2.0 SITE CHARACTERISTICS

2.1S Geography and Demography

2.1S.1 Site Location and Description

Figure 2.3S.2-1 Comparison of 1997, 1999, and 2000 Wind Direction Frequency Distributions

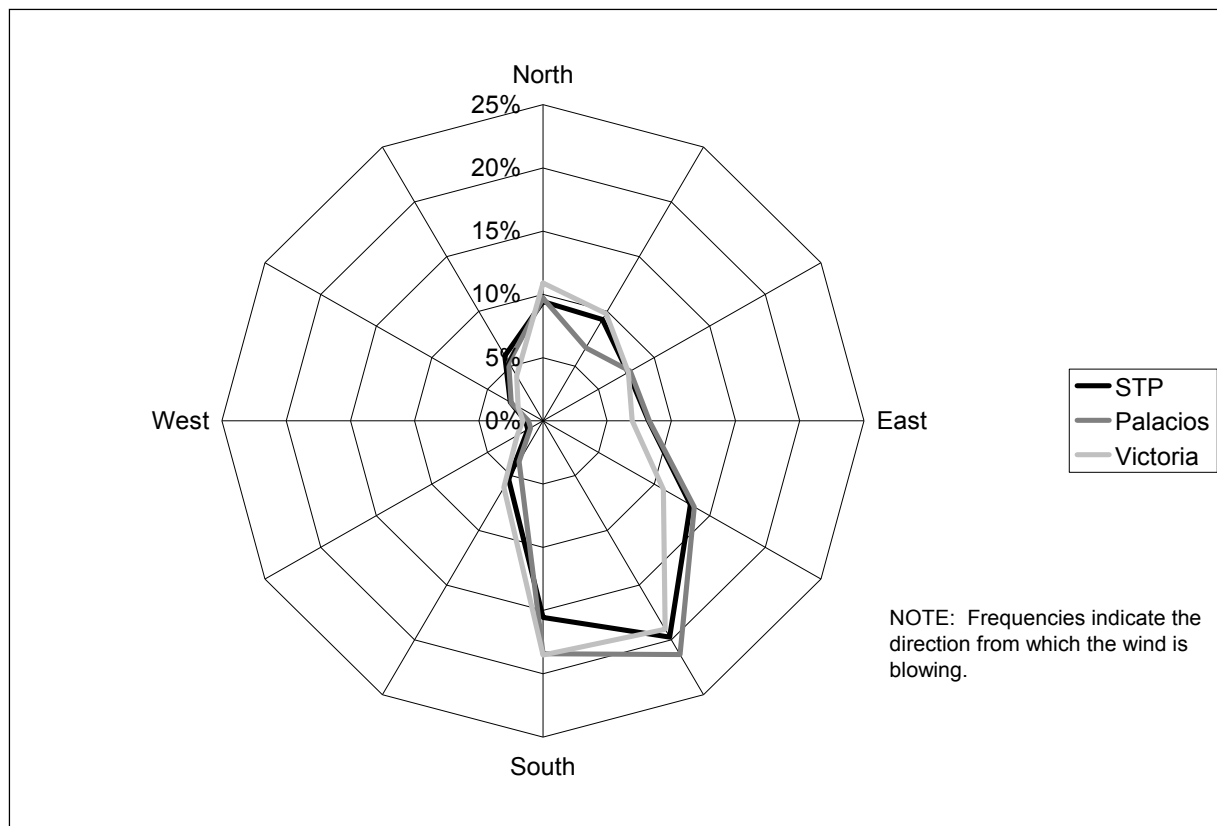
In order to confirm this hypothesis, the staff generated a comparison of annual wind direction frequencies among the STP, Palacios, and Victoria hourly data for the years 1997, 1999, and 2000. This comparison, shown in SER Figure 2.3S.2-1, indicates a similar distribution among all three sites. The staff also compared annual average wind speeds among all three sites for the same three-year time period. The staff found that the STP 10-m (33-ft) level average wind speed of 4.1 m/s (13.5 ft/s) is consistent with the 6.1-m (20.0-ft) level average wind speed of 4.1 m/s (13.5 ft/s) at Victoria but somewhat lower than the 5.0 m/s (16.4 ft/s) average wind speed recorded at Palacios. The staff issued RAI 02.03.02-4a, requesting the applicant to

Figure 2.3S.3-3 STP Stability Class Frequency Distributions

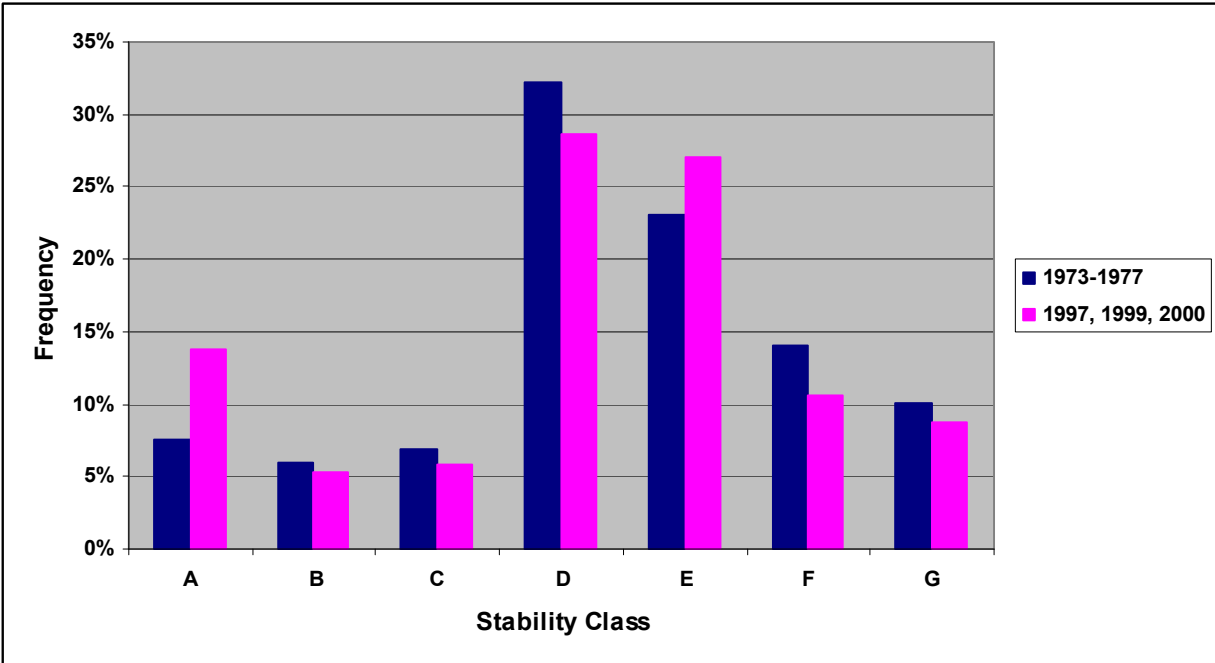
The stability class frequency distribution for both data sets in SER Figure 2.3S.3-3, also show reasonable agreement. Nonetheless, the staff issued RAI 02.03.03-3, asking the applicant to explain the six percent frequency increase of onsite Stability Class A (extremely unstable) conditions from the original data set to the current data set (see SER Figure 2.3S.3-3).

Figure 2.4S.5-1 Westward PMH Storm Tracks Used in the NRC Staff's SLOSH Simulations

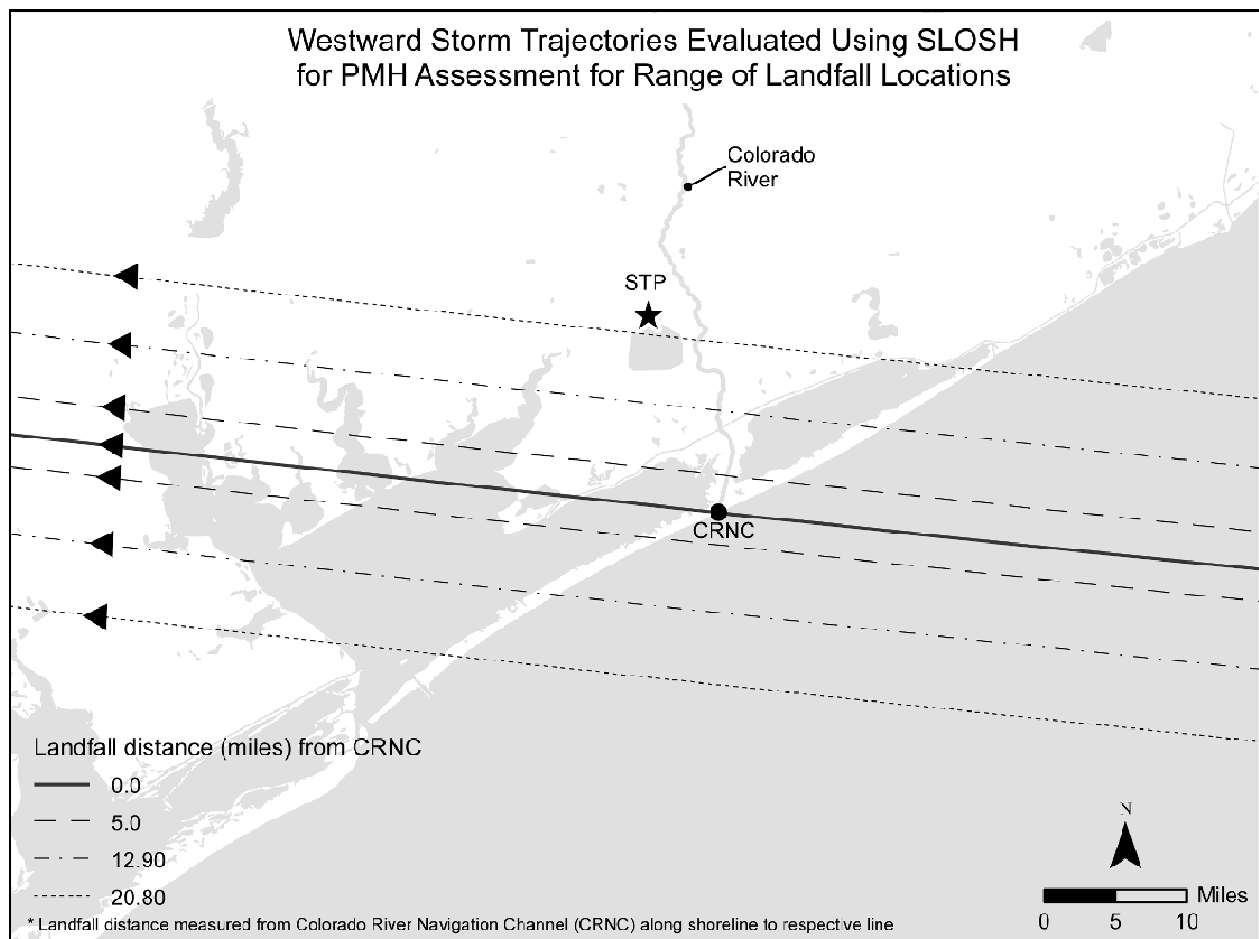
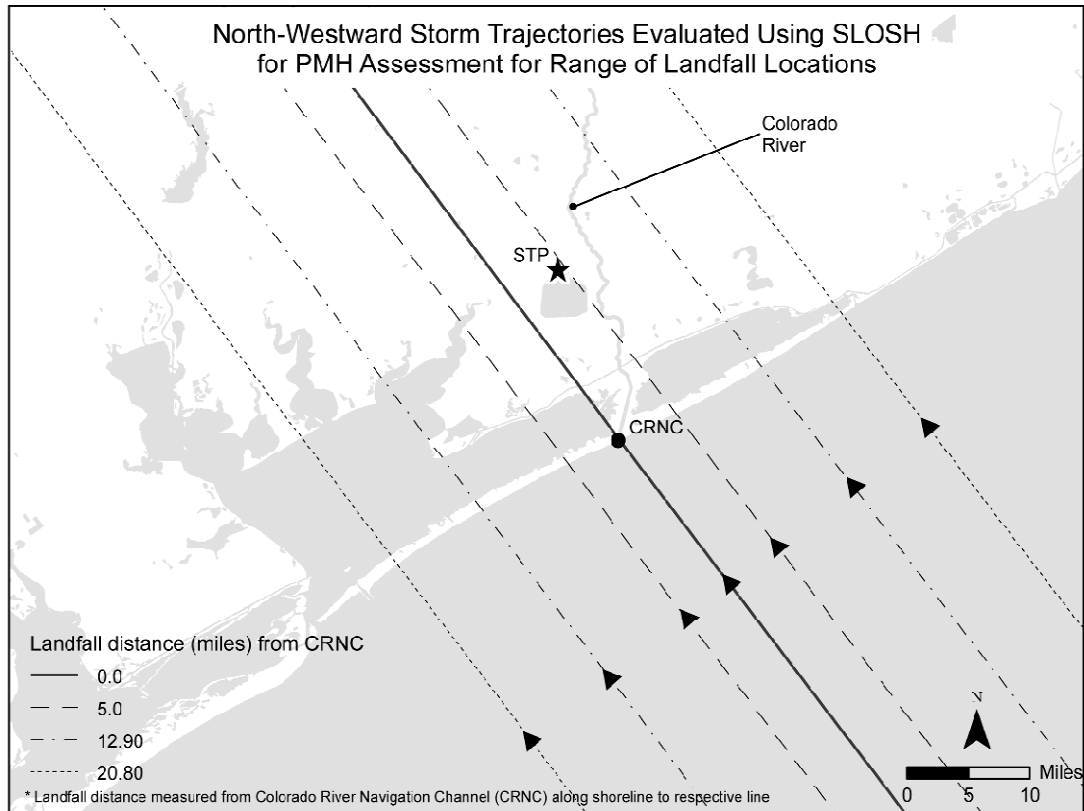
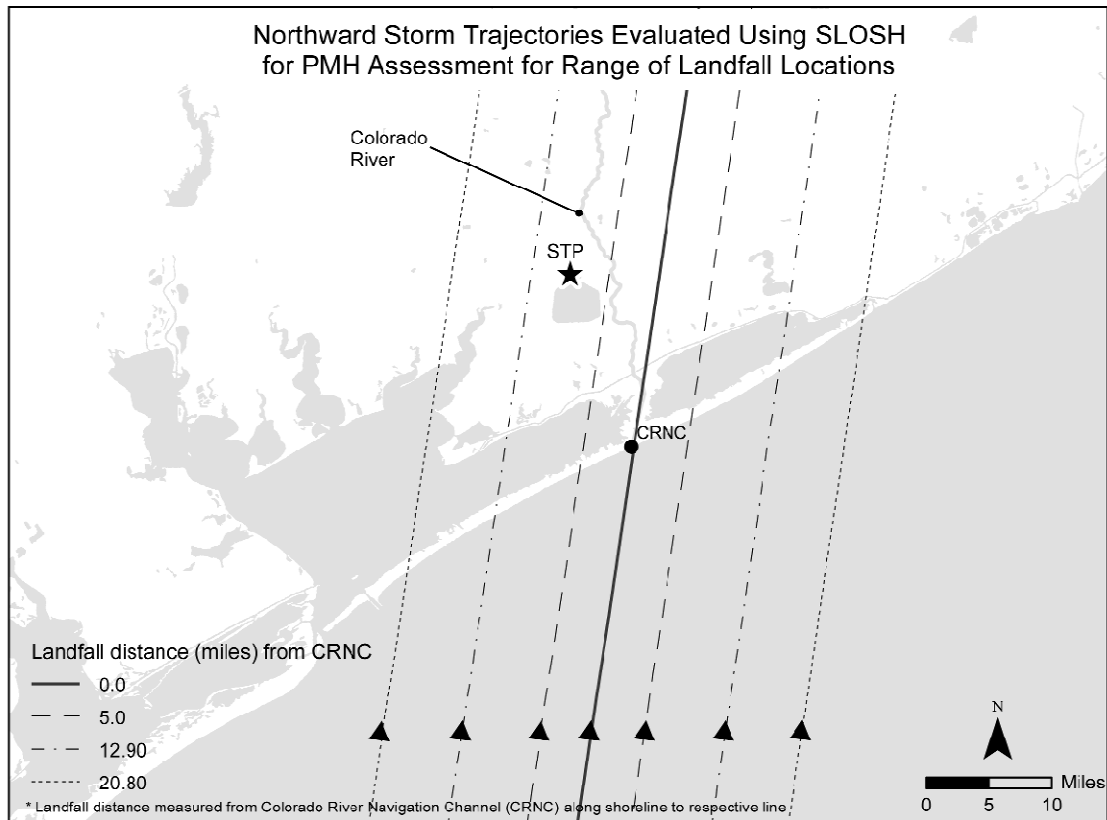
The PMH storm tracks used in the staff's independent analysis are shown in SER Figures 2.4S.5-1, 2.4S.5-2, and 2.4S.5-3. These figures are differentiated by track direction. Each figure shows seven track lines (three pairs offset to either side from a central track line by distances equal to different radii to maximum winds). In these figures, the central track is represented by the solid line, and the corresponding tracks to the west and the east are represented by matching broken lines. In each figure, several tracks use the same track line with different sets of track parameters (forward speed and radius to maximum winds). The total number of tracks represented in each figure is 27, with 9 along the central line and 3 along each of the other 6 lines.

Figure 2.4S.5-5 NRC Staff-Estimated PMSS Water Surface Elevations at the STP Site

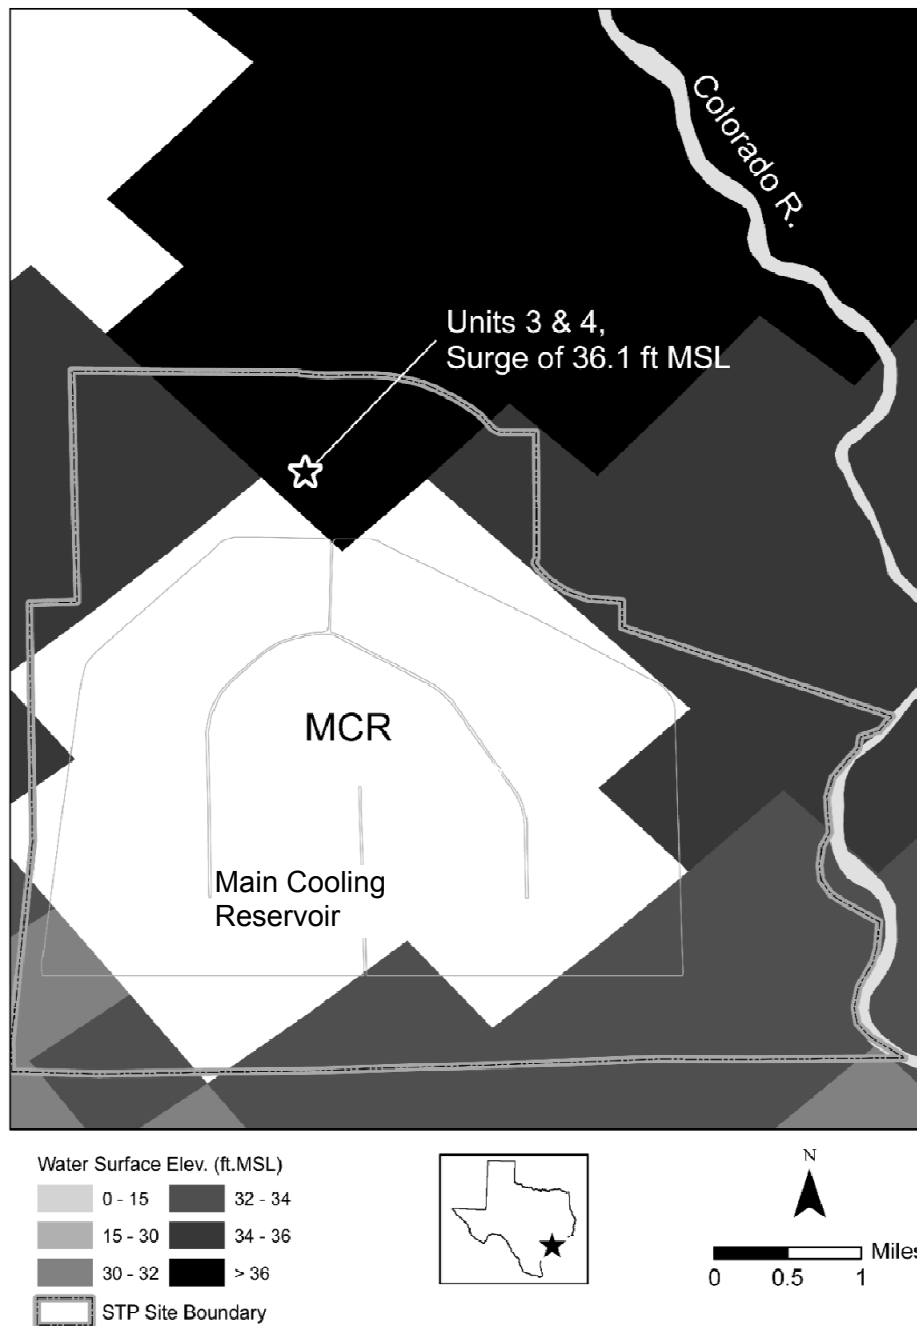
The SLOSH simulations indicated that the maximum storm surge water surface elevation near the STP, Units 3 and 4, site would be produced by a large (in terms of radius to maximum winds), fast-moving (in terms of forward speed) storm that would produce prevailing winds blowing from the east toward the STP, Units 3 and 4, site. The staff prepared a map of maximum water surface elevation on the SLOSH computational grid from these 81 PMH storm-track simulations for the two sea-level rise scenarios (Figure 2.4S.5-5). As expected, the staff's

Figure 2.5S.1-5 Map of Growth Fault Projections, Lineaments, and Topographic Survey Points Within the STP Site Area (Reproduced from FSAR Figure 2.5S.1-45)

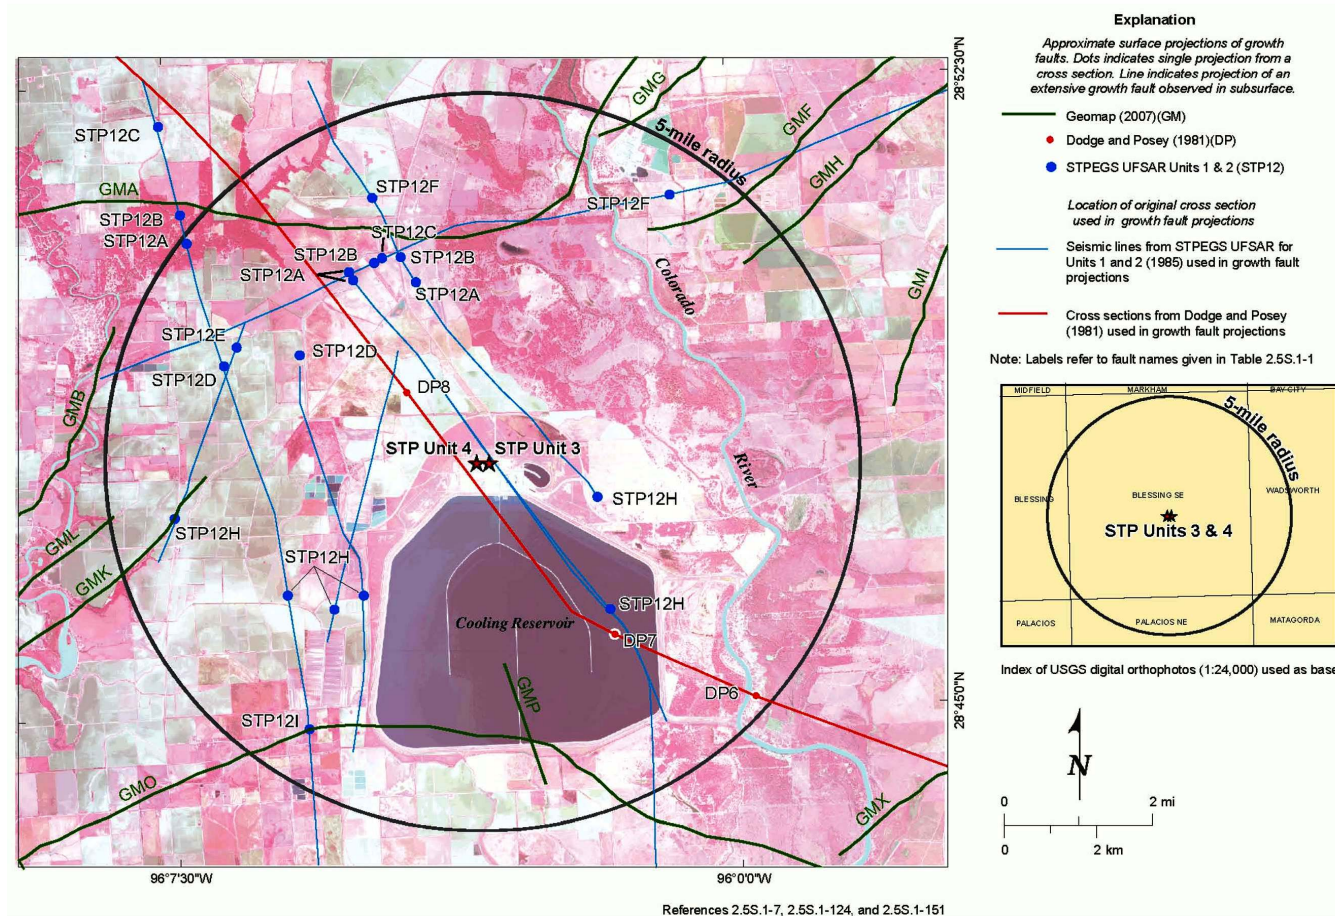
The staff issued multiple RAIs related to the applicant’s evaluation of growth fault Matagorda STP12I (Matagorda GMO). In RAI 02.05.01-9, the staff asked the applicant: (1) to explain why the evaluation only measured the topographic offset at four locations along the surface projection of growth fault Matagorda STP 12I (Matagorda GMO); and (2) to discuss the uncertainties in projecting this growth fault to the surface. In its response to RAI 02.05.01-9, dated October 1, 2008, the applicant stated that the locations of the topographic surveys (as shown in SER Figure 2.5S.1-5) are based on evidence for monoclinical folding that the applicant observed during initial field reconnaissance studies. The applicant’s survey did not extend beyond the westernmost observed folding but did include one location (STP L4) that was along strike with the folding and was the closest available location to the cooling reservoir. The applicant stated that even though there are uncertainties in the projection of growth fault Matagorda STP 12I (Matagorda GMO), the fact that the monoclinical folding is evident in three of the four survey profiles provides confidence in the applicant’s “best estimate” projection of Matagorda STP 12I (Matagorda GMO).

The staff reviewed the applicant’s response to RAI 02.05.01-9. The staff concurred with the applicant’s reasoning for selecting profile locations STP L1 through STP L4 based on the evidence for monoclinical folding at the surface and on the applicant’s preferred surface projection for growth fault STP GMO. The applicant’s response assumes that the surface projection of growth fault Matagorda STP 12I (Matagorda GMO) bends to the southeast around the cooling reservoir (as shown in SER Figures 2.5S.1-4 and 2.5S.1-5) rather than through the reservoir.

Figure 2.5S.2-7 Response Spectra from the Sensitivity Test and Comparison to the Site-Specific SSE

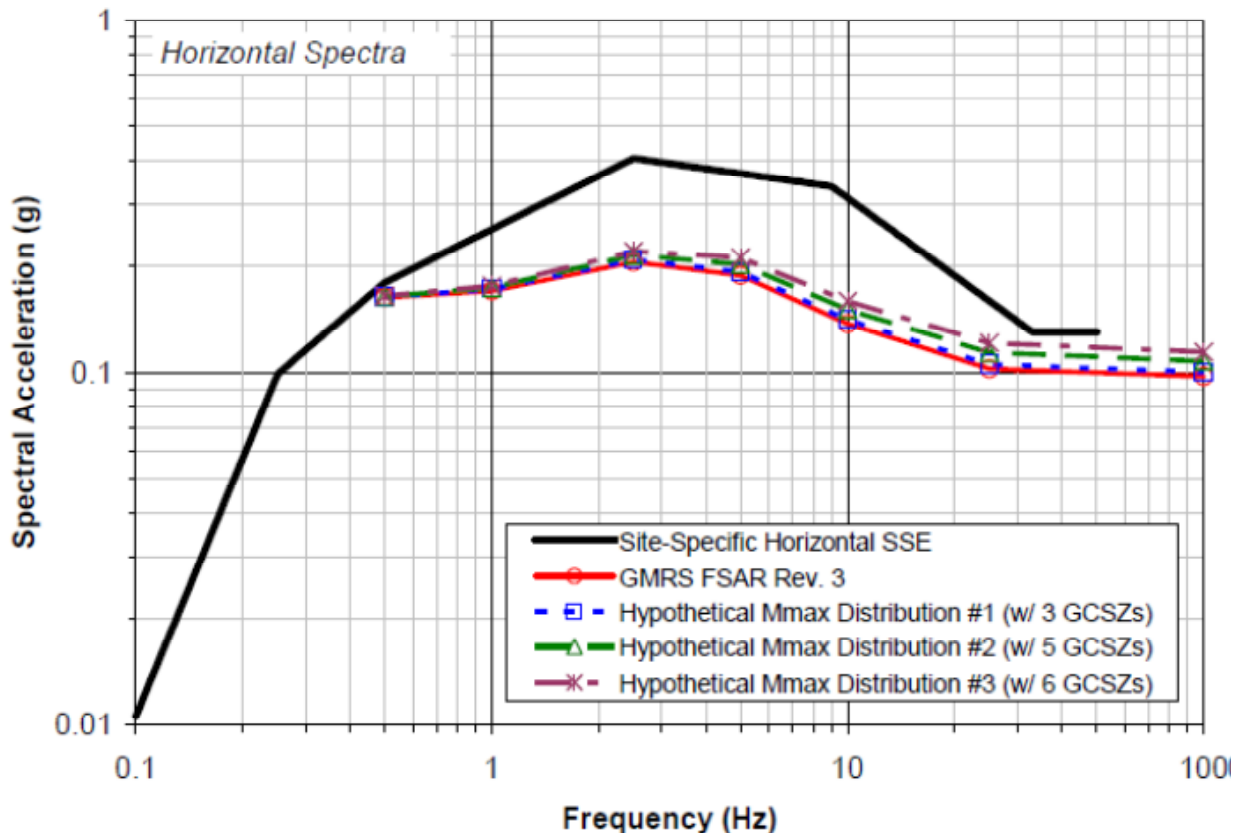
exception of Scenario 3, which increased the GMRS by as much as 18% at a spectral frequency of 25 Hz. However, Scenario 3 includes an $M_{\max}$ update to the Woodward Clyde B43 source zone, which is located very far from the two 2006, Gulf earthquakes (273 km (170 mi) and 635 km (395 mi)), and therefore, Scenario 3 is not considered plausible by the staff. The GMRS resulting from the three scenario $M_{\max}$ updates are shown below in SER Figure 2.5S.2-7.
